JRPP – SUPPLEMENTARY REPORT

- Application: 2015SYE140 – Inner West – DA2015000584
- Address: Longport Street, Lewisham (aka 2-32 Smith Street, Summer Hill)
- Development description: To construct a 6 part 9 storey residential flat building comprising 98 dwellings, over 3 levels of basement car parking for a total of 105 car spaces and the creation of a new private access across Hawthorne Canal with associated on-street parking, road works and landscaping. This is referred to as the stage 4 DA.

Applicant's review of Gross Floor Area (GFA)

Image 2: Typical floor plan depicting amended GFA calculation

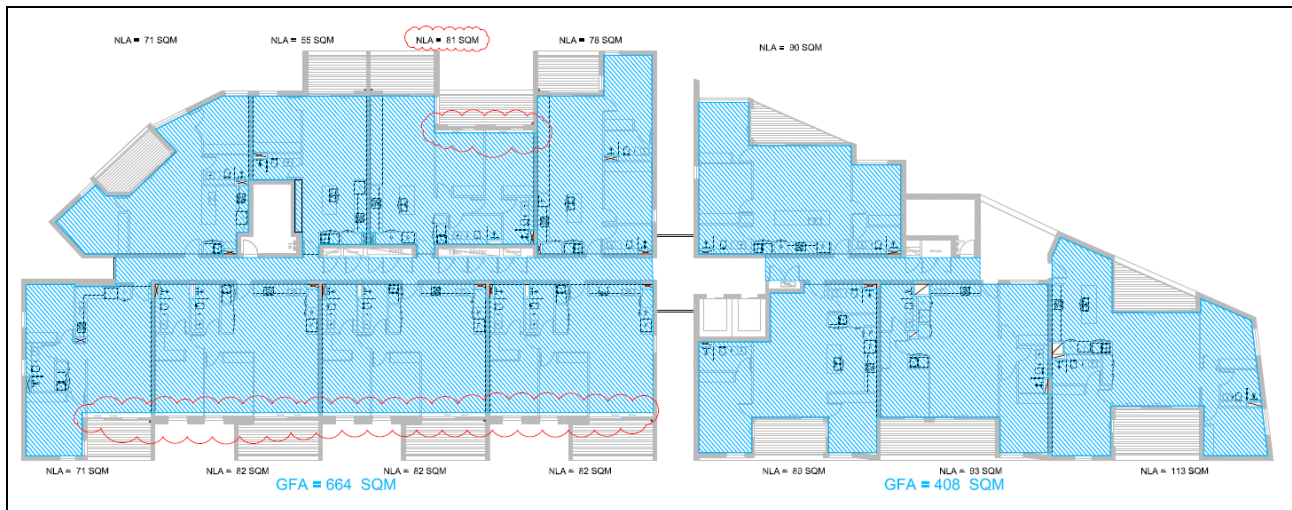
- The calculation of the GFA has been reviewed and as directed by the JRPP, the central corridors on ground to level 8 have now been included as part of the GFA calculation.

- The calculation of the GFA of each level has been reviewed and has excluded the area for mechanical services and ducting which had previously been included in the GFA calculation.

- To ensure strict numerical compliance with the terms of the Concept Approval, the eastern elevation and some dwellings on the western elevation of the proposed building have been recessed slightly to provide a reduction in the overall GFA to ensure that the maximum residential GFA set by the terms of the applicable Concept Plan is not exceeded.

- It is confirmed that the amended GFA calculations now include all corridor areas, including the area at the northern end of the building which was previously excluded. The amended GFA calculations for a typical floor plan in the building is shown below:
